ANN ARBOR HISTORIC DISTRICT COMMISSION

Staff Report

ADDRESS: 436 Third Street, Application Number HDC15-166

DISTRICT: Old West Side Historic District

Existing T&G siding (Pattern #116) on Duplex

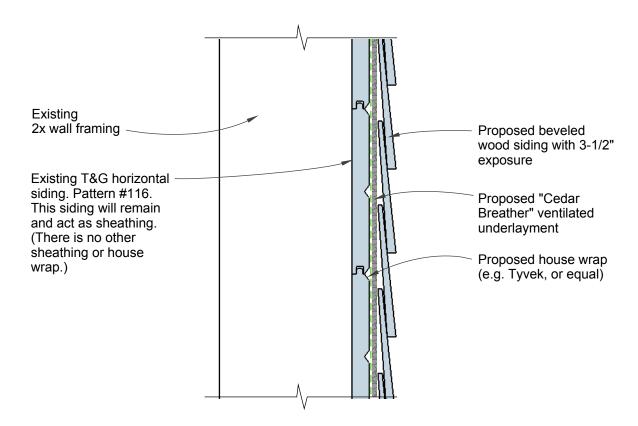
- 4. The existing wood siding has many gaps and cracks and was not intended to be installed horizontally (it should be a vertical siding). The building's new use as a residential duplex necessitates a siding surface that performs better than the current one. It is not known whether the existing horizontal siding dates to the period of significance, though staff suspects not since there have been many, many alterations to this building in the past. New siding could be the same pattern installed vertically, but it is staff's opinion that that would change the look and feel of the structure more than installing horizontal lap siding with the same reveal as the horizontal siding would. The new siding would be installed over the top of the existing. The applicant proposes to remove the existing trim, pack it

out, and reinstall it to maintain the existing trim proportion.

Extend existing shed roof and install new brackets

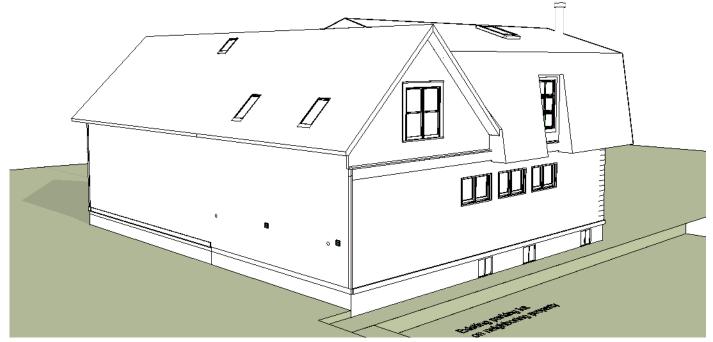
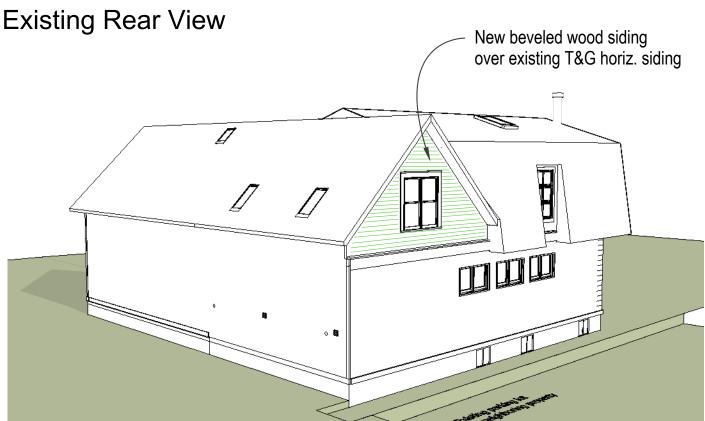
- 3. On the duplex, the shed roof extension's proposed tie-in with the front porch roof on the carriage house is more visually appealing than the current lonely piece of shed roof. From a performance standard, extending the shed roof will help shed water from the steeply-pitched gambrel roof and keep it off the walls and away from the foundation.
